UNITED STATES PATENT AND TRADEMARK OFFICE

Office Action Summary	Application No. 10/567,480	Applicant(s) SCHLOESSER ET AL.	
	Examiner VICTORIA HICKS	Art Unit 3772

DETAILED ACTION

FIG 2

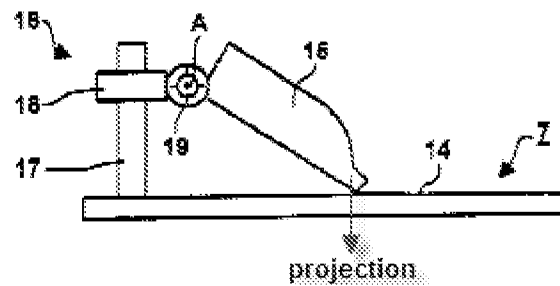
In regards to claim 2, Pauli teaches in Figures 1 and 2, column 2, lines 64-67 and column 4, lines 22-32 a frame (15, 18, 19); a projection extending from one end of the frame, the projection defining a pivot point; a first assembly (17, 18) connectable to a second end of the frame (15, 18, 19), the first assembly (17, 18) including a vertically-oriented bearing (17) having a first end and a second end, the first end extending through an opening (sleeve 18) in the frame (15, 18, 19), the second end of the frame (15, 18, 19) configured to move along the vertically-oriented bearing (17) to provide a first range of motion of the frame (15, 18, 19) relative to the couch (7, 14) about the pivot point; and a second assembly (7, 8, 10, 14) including a horizontally-oriented bearing (8), the second end of the vertically-oriented bearing (17) configured to move along the horizontally-oriented bearing (8) to provide a second range of motion of the frame (15, 18, 19) relative to the couch (7, 14) about the pivot point.

In regards to claim 5, Pauli teaches the apparatus of claim 2. Pauli teaches in Figures 1 and 2, column 2, lines 64-67 and column 4, lines 22-32 that the first range of motion comprises one of a pitch rotation, a roll rotation, and a yaw rotation and the second range of motion comprises one of a pitch rotation, a roll rotation, and a yaw rotation.

In regards to claim 6, Pauli teaches the apparatus of claim 2. Pauli teaches in Figures 1 and 2, column 2, lines 64-67 and column 4, lines 22-32 that the first range of motion is different than the second range of motion.

In regards to claim 7, Pauli teaches the apparatus of claim 2. Pauli teaches in Figures 1 and 2 and column 4, lines 22-32 that the first assembly (17, 18) comprises a track (17) and a carriage (18) connected to the frame (15, 18, 19), the carriage (18) adapted to move along the track (17).

In regards to claim 11, Pauli teaches the apparatus of claim 2. Pauli teaches in Figures 1 and 2 and column 4, lines 22-32 a third assembly (19) connectable to the second end of the frame (15, 18, 19), the third assembly (19) operable to provide a third range of motion of the frame (15, 18, 19) relative to the couch (7, 14) about the pivot point.

In regards to claim 12, Pauli teaches the apparatus of claims 1 and 11. Pauli teaches in Figure 2 and column 4, lines 22-32 that the third range of motion comprises one of a pitch rotation, a roll rotation, and a yaw rotation.

In regards to claim 13, Pauli teaches the apparatus of claims 2 and 11. Pauli teaches in Figure 2 and column 4, lines 22-32 that the third range of motion is different than the first range of motion.
